**CITY OF SAN ANGELO  
BELL STREET PAVING, WATER AND WASTEWATER IMPROVEMENTS ALL PHASES  
SAN16188**

**ADDENDUM NO. 1**

**December 21, 2017**

**00 91 13      ADDENDUM NUMBER 001**

W-1  
65

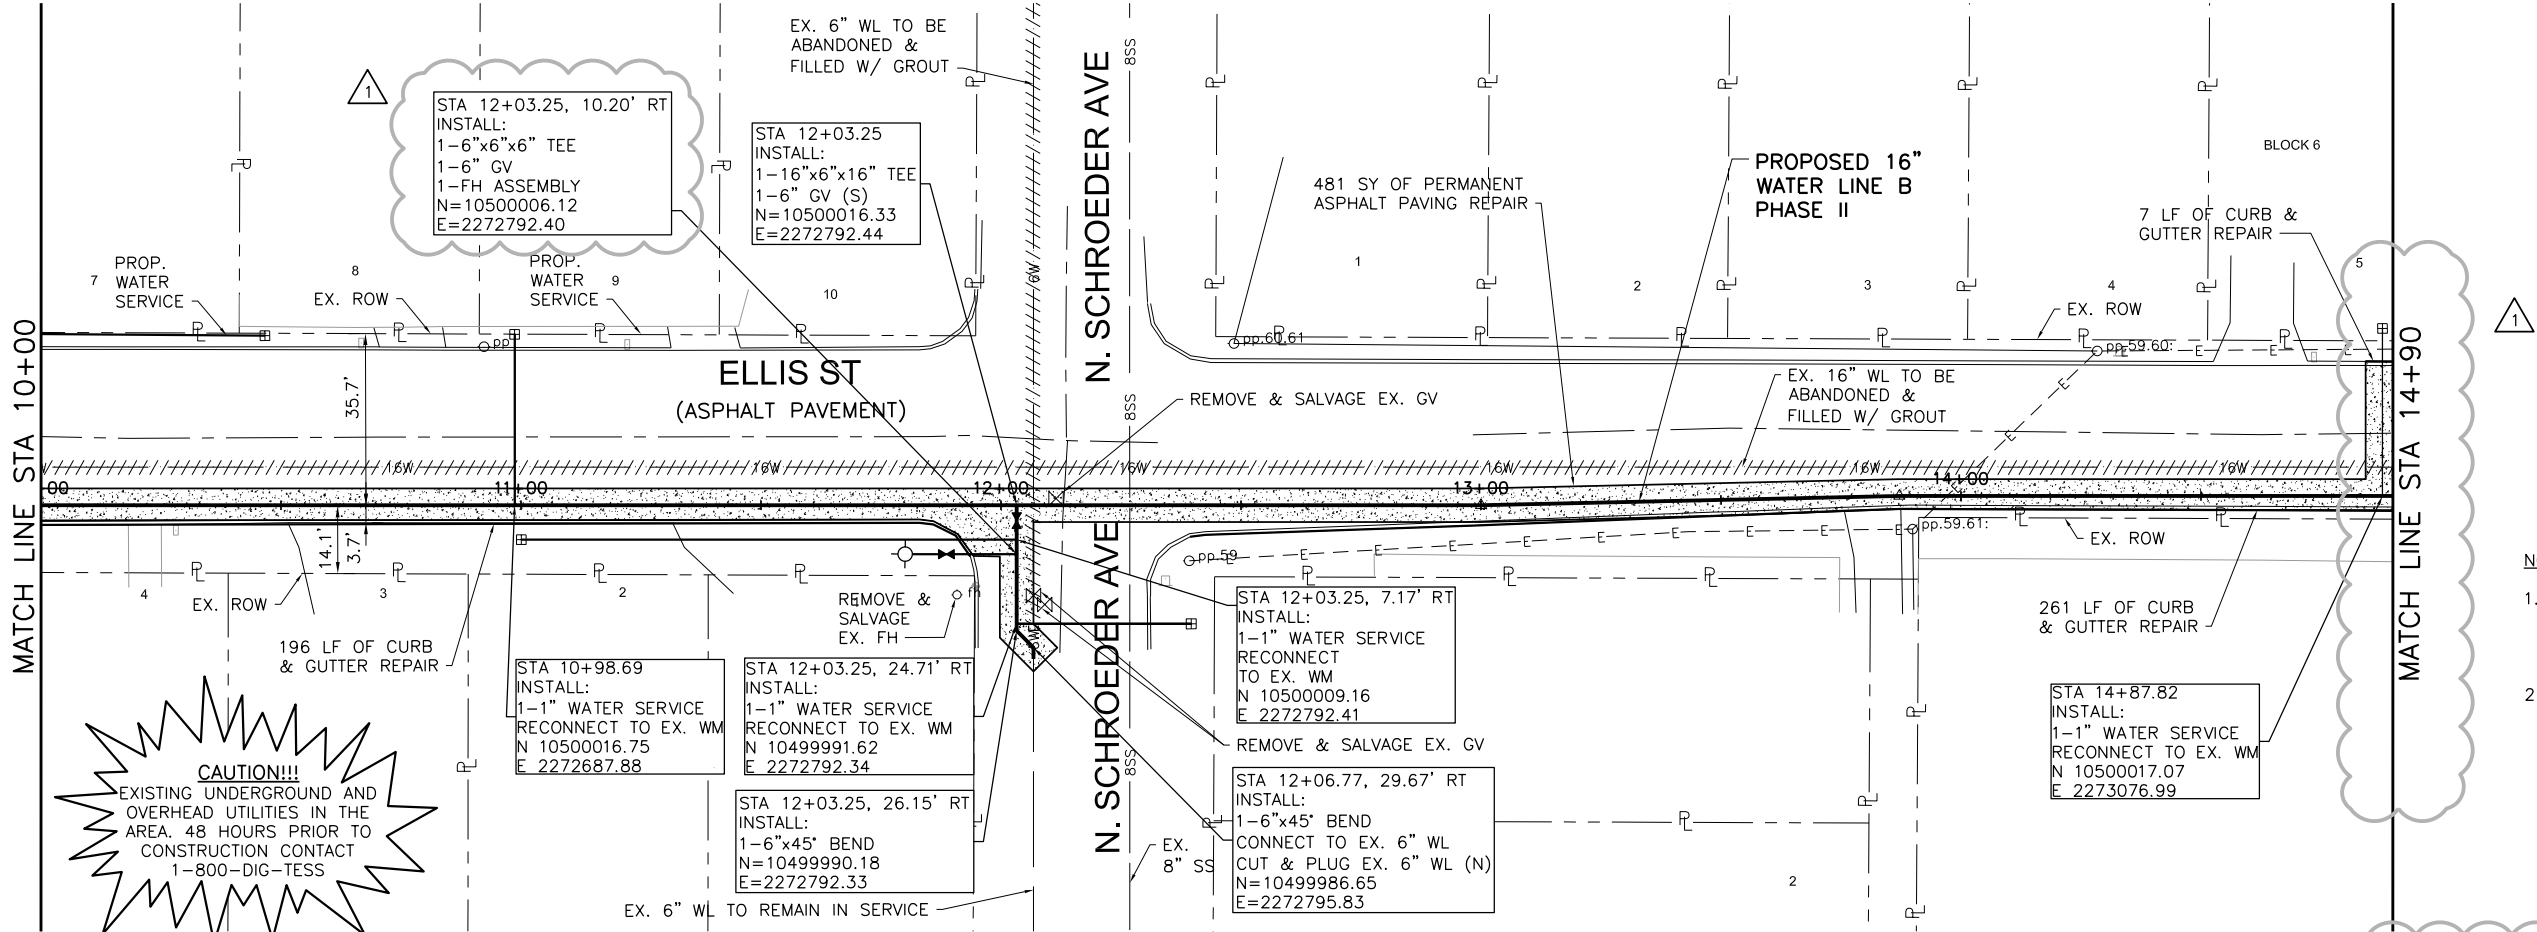
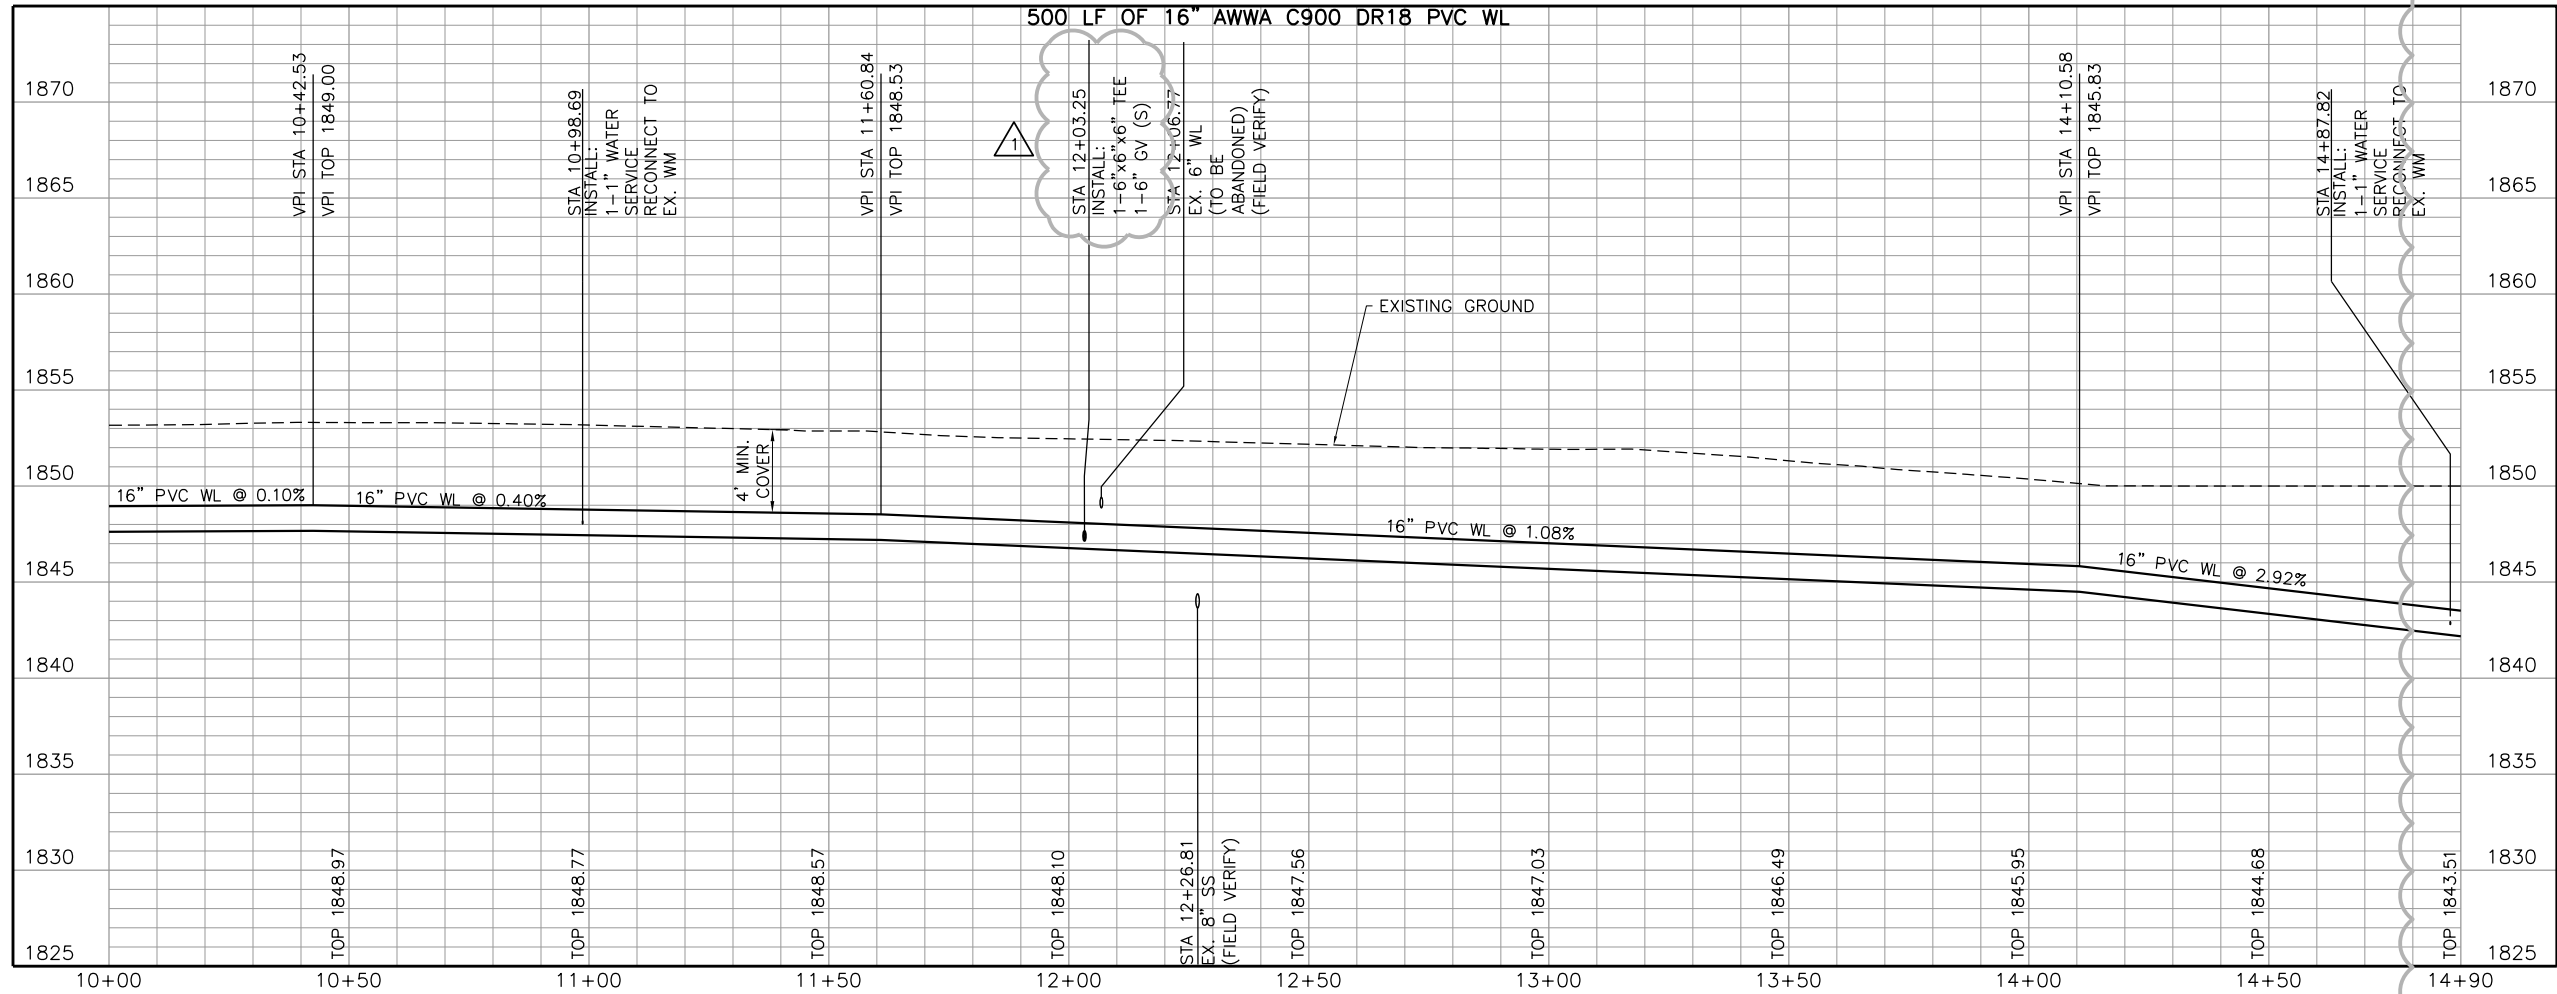
Phase	Replace Sheet	With Sheet
1, 2, 3	NOTES-1	NOTES-1
1,2, 3	NOTES-2	NOTES-2
2	W-1	W-1
2	W-2	W-2
2	W-9	W-9
2	W-10	W-10
2	W-15	W-15
2	W-16	W-16
3	W-5	W-5
3	W-7	W-7
3	SS-3	SS-3
3	SS-4	SS-4

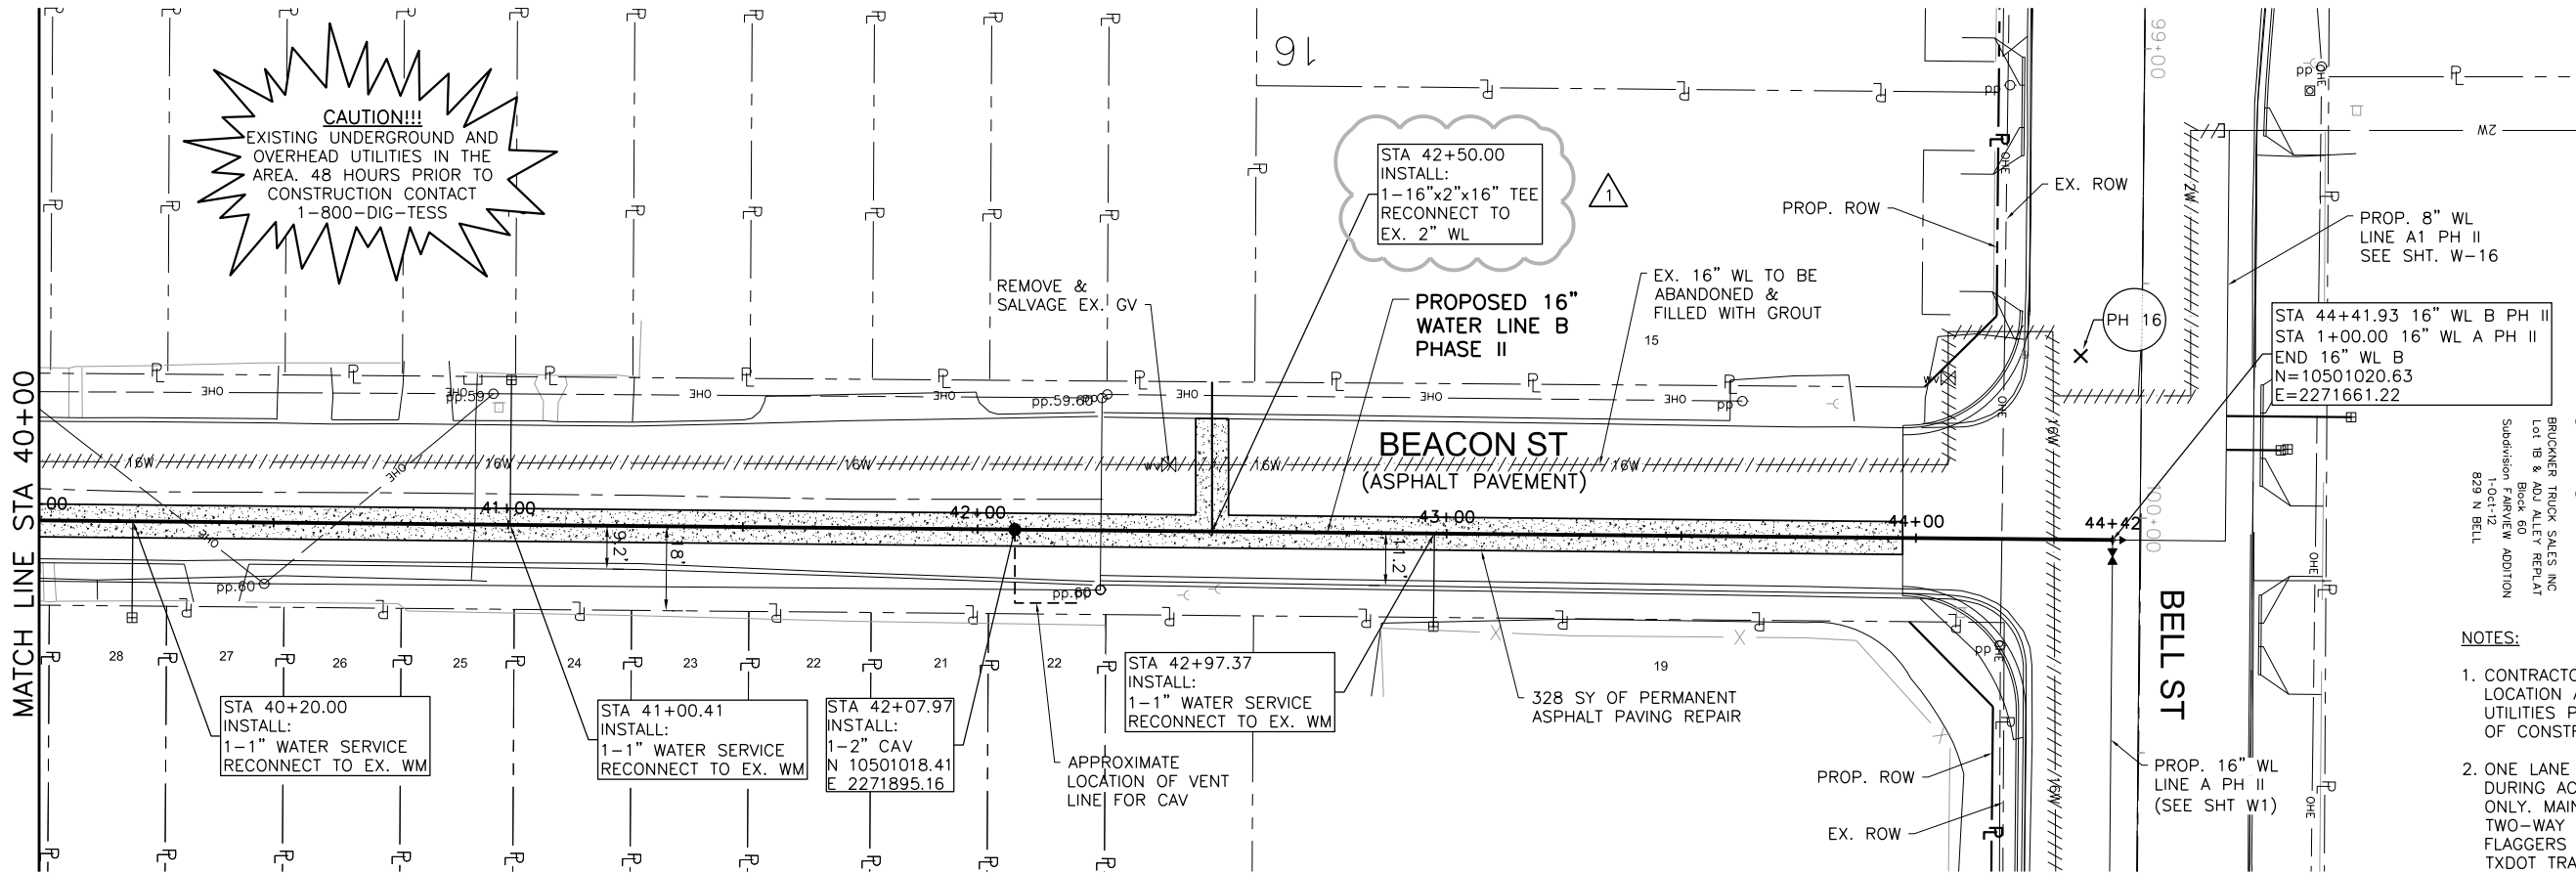
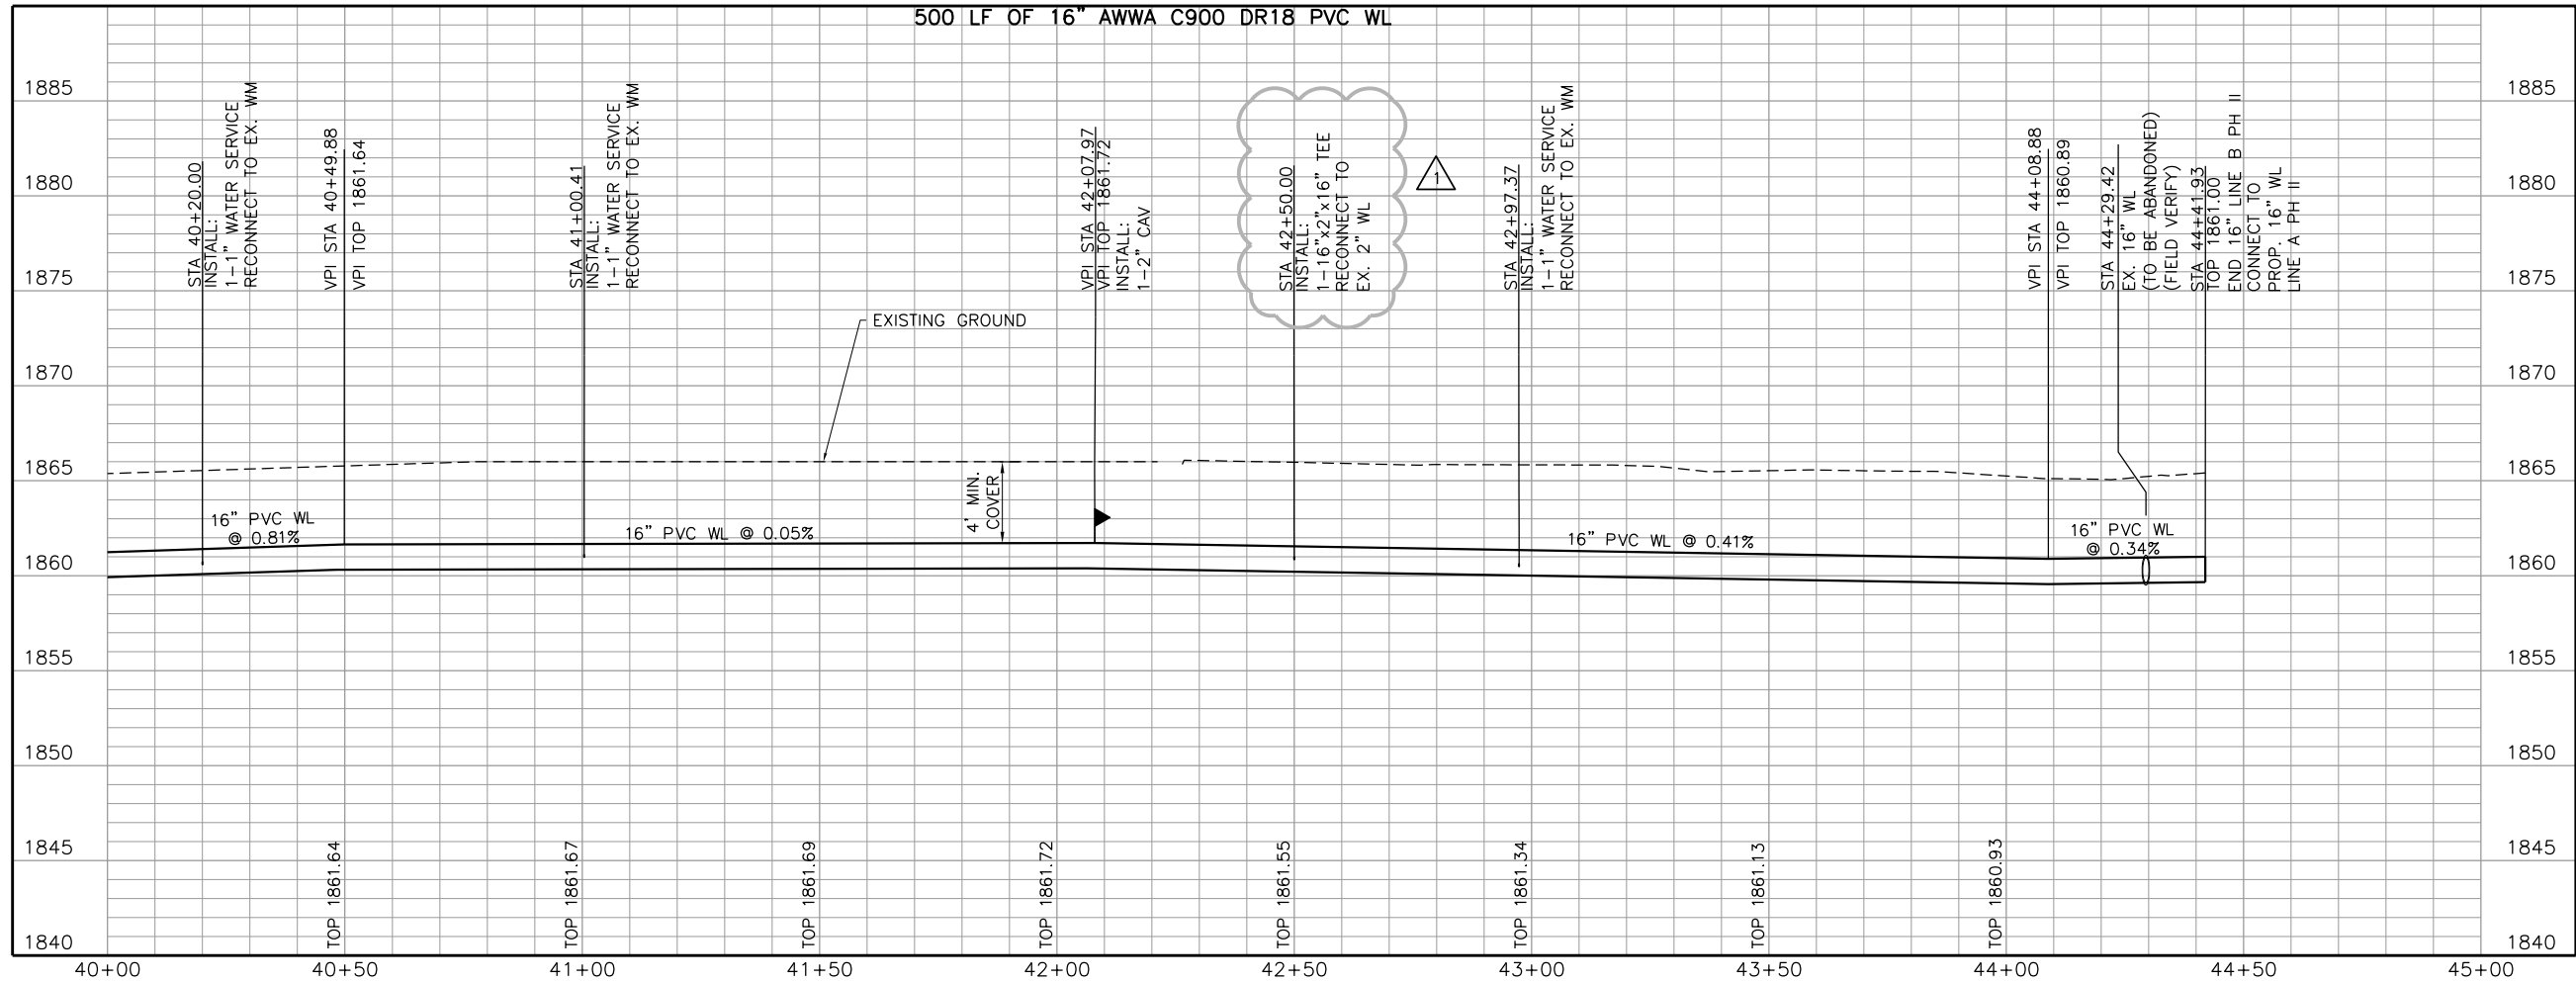
Project:	Bell Street Paving, Water, and Wastewater Improvements - All Phases		FNI Project No:	SAN16188	Last Updated:	12/21/2017
11	Asphalt Repair;  Are we going to be required to put a temporary skin patch on utility trench cuts or can the base material just be maintained ?	Temporary asphalt repair is required unless final paving performed within 72 hours of completed backfill.	Refer to Addendum 01, Item A1-5 A.			
12	Box Culvert;  On phase II — water sheet 10 at station 15+20 there is an existing Concrete box culvert with a concrete apron, Approximately fifty feet wide, and five feet in depth . This will need to be a road bore, can we have a bid item For this crossing?	This section of the 16" waterline will be updated to show a By Other Than Open Cut Installation Method and the quantity will be added to the existing by other than open cut bid item in the Price Proposal.	Refer to Addendum 01, Updated Drawings, Phase II Sheet W-10 and the Updated Technical Specifications, Price Proposal.
